CHÂTEAU LAURIER PROPOSED ADDITION

# CULTURAL HERITAGE IMPACT STATEMENT

CAPITAL HOLDINGS LTD.  
JANUARY 2017

1 RIDEAU STREET, OTTAWA, ON

**BELOW** Proposed addition north elevation (N.T.S.). *architectsAlliance*

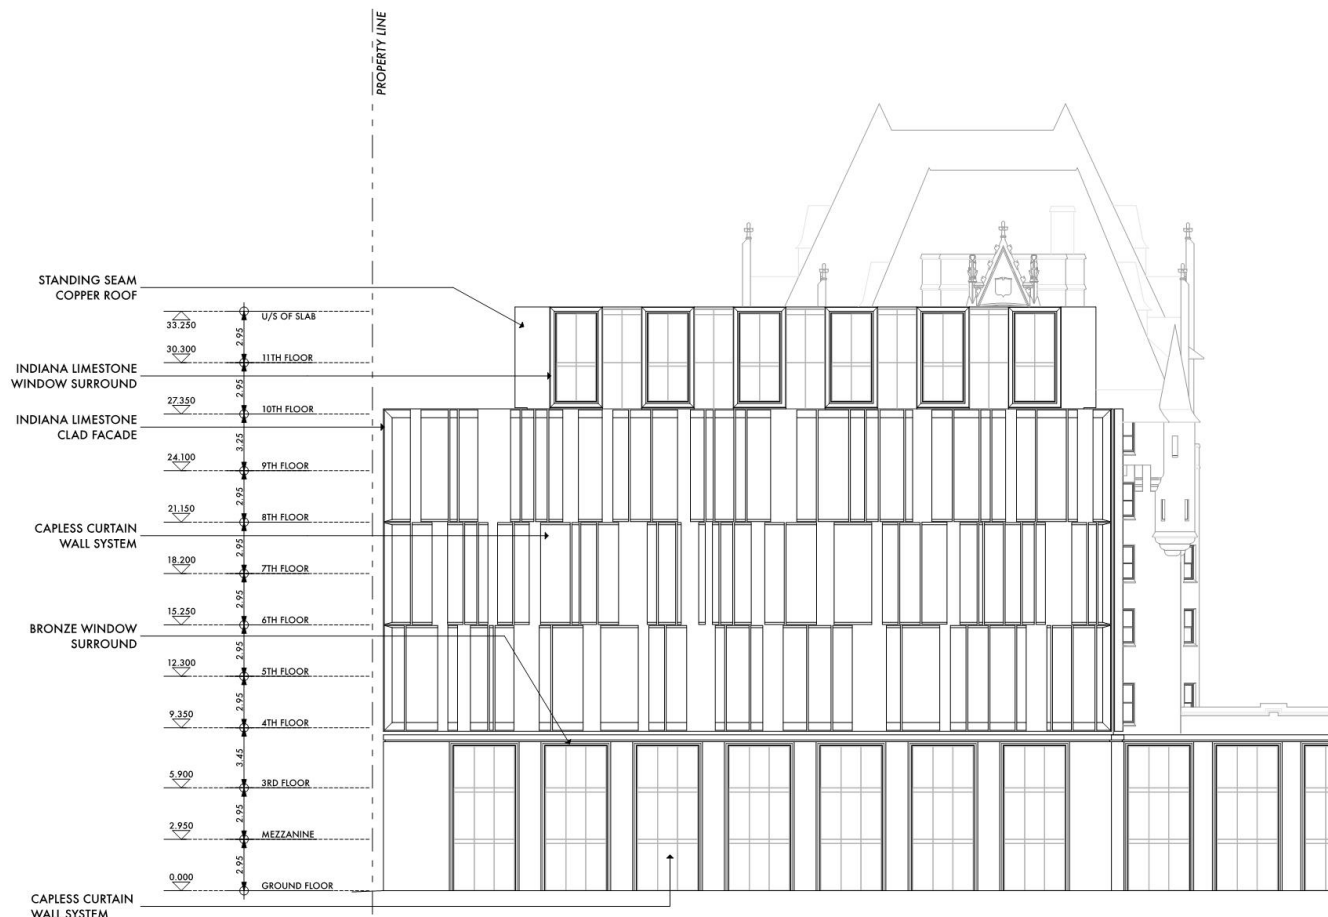
1. The limestone "screen: wall provides a contemporary foil for mass/void when seen at an oblique angle, as well as a "texture" to the middle layer skin. However, design development should consider receding and projecting planes within the proposed addition massing to better respond to the massing modulation found within the existing building where the longest relevant unbroken lengths are 35.6m on the west elevation and 14.0m on the east elevation (40.9m broken twice by projecting bays). This is especially important as the setting allows the proposed addition to be viewed in three dimensions.

4. The proposed addition does not reference this critical layer of the existing building, weakening the compatibility between the proposed addition and existing building. Detailed study of this existing layer is recommended as part of developing a compatible or supportive complementary yet contemporary architectural response to the interstitial layer. Opportunities to reduce the unbroken horizontal definition between the middle and roof layers of the proposed addition should be explored within a new interstitial layer to more directly respond to this important characteristic of the existing building. Situate the most “active” architectural detailing within the new interstitial layer of the proposed addition to more directly respond to the character of the existing building’s interstitial zone. Consider restraining the level of architectural variety to enhance the role of this layer. (Refer to Middle Layer under Massive Scale below).

**RIGHT** Proposed addition west elevation (N.T.S.). *architectsAlliance*

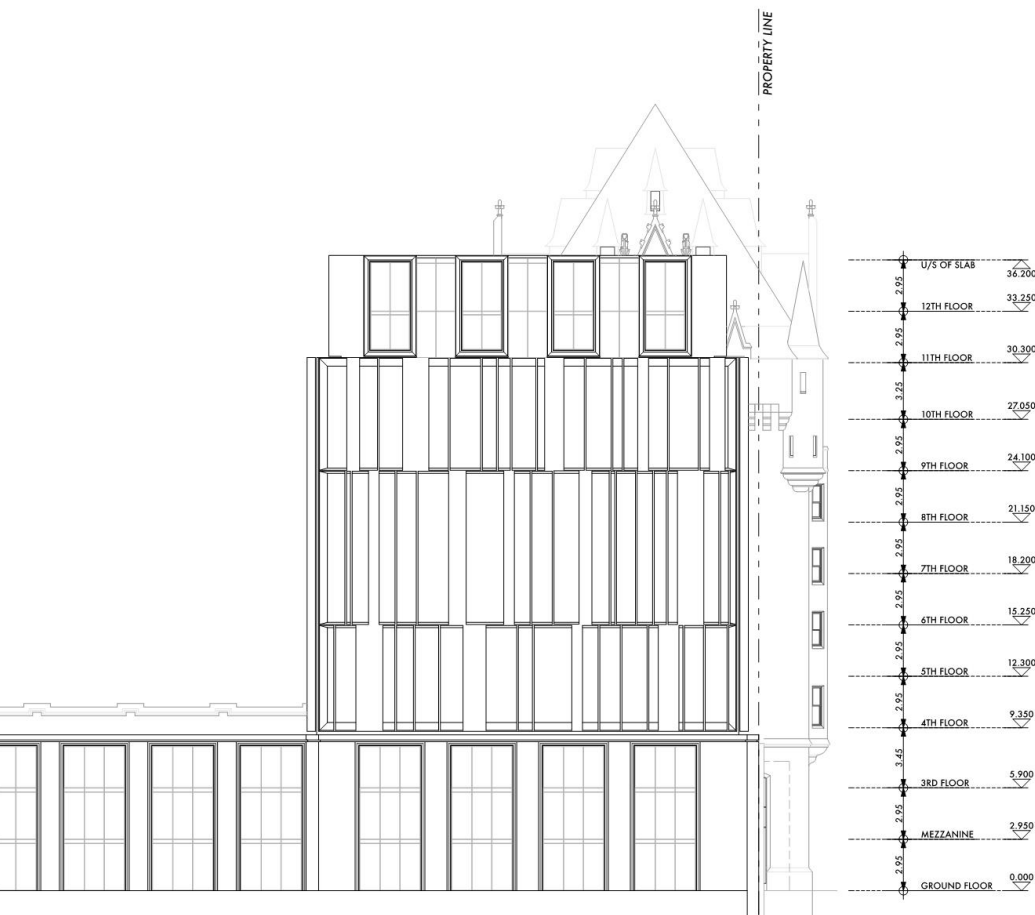
5. Explore opportunities to develop the design of the roof “floors” into a more expressive formal composition, to increase compatibility with the expressive roof of the historic place. The size of the roof (especially when stepped or scaled back to afford better visual access to the historic roof) will provide subordination; the expressiveness will provide compatibility. Consider that the existing roof slope is important to the legibility of the upper edge of an interstitial layer and to responding to the dramatic and romantic setting.

**BELOW** Proposed addition east elevation (N.T.S.). *architectsAlliance*

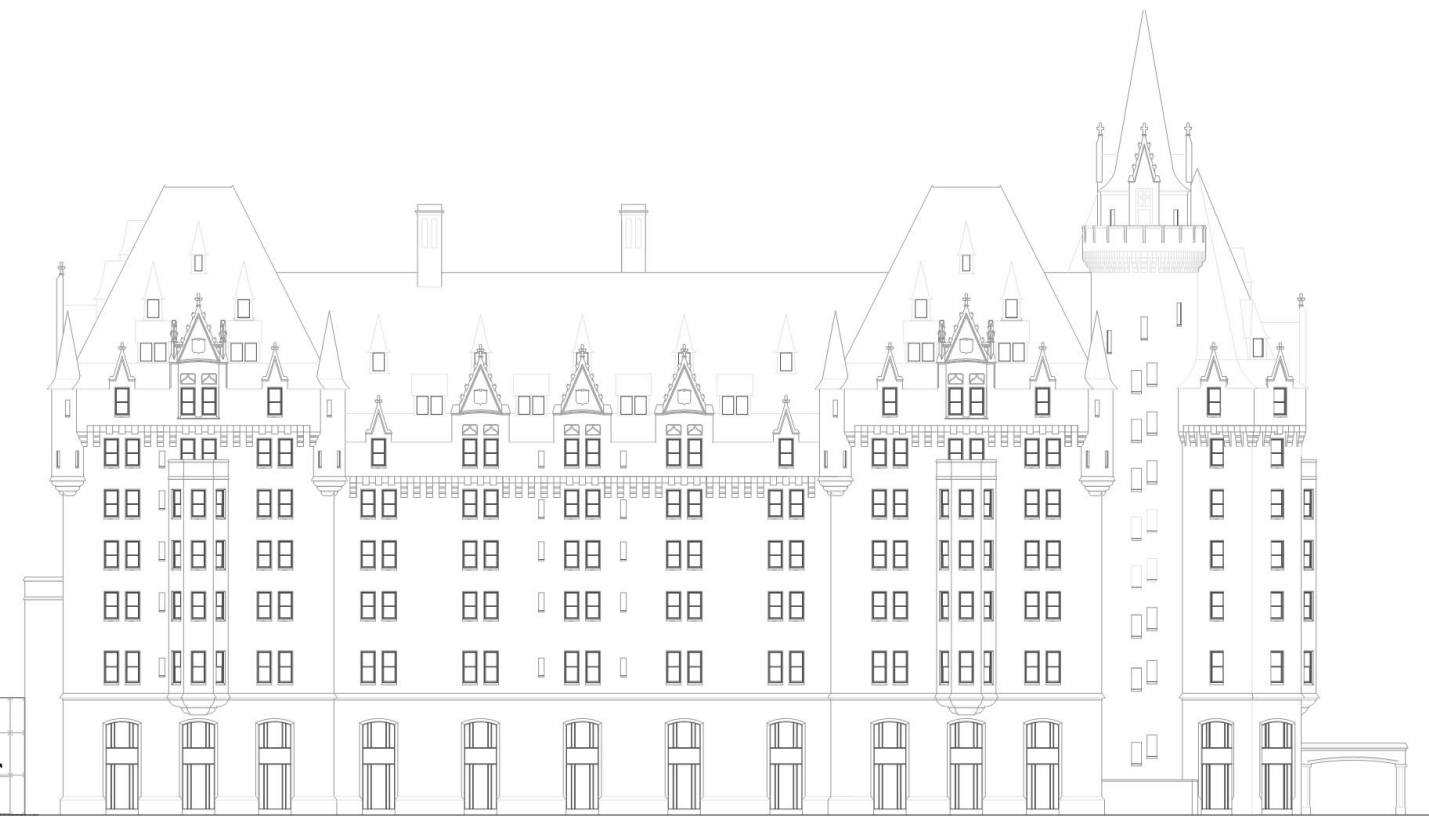
1. The base layer is required to be the most visually heavy and massive. While the proportion of the proposed openings is compatible to the scale of the existing west elevation openings, the significant difference in solid-to-void results in a very different visual perception, emphasizing void. The width of the stone between windows and the height of the stone area above the openings should be increased to provide greater visual weight within the proposed base.

2. Simplify the fenestration framing detailing to better harmonize with the simpler or non-existent detailing of heritage building fenestration. Where material change detailing is appropriate, seek to use a less contrasting material that maintains visual simplicity.

4. The use of depth within the proposed elevations and splays within the stone piers are positive approaches that generate “mass” in a contemporary fashion as viewers move around the proposed addition.
5. Enhance the visual weight of the proposed addition elevations, for example by increasing the regularity of the glazing placement and legibility of design.
6. In developing the facade design, consider adjusting for quantity of solid materials within the middle layer to increase the sense of mass. The solid-to-void relationship should be carefully studied to provide a higher degree of mass while maintaining a contemporary amount of glazing.
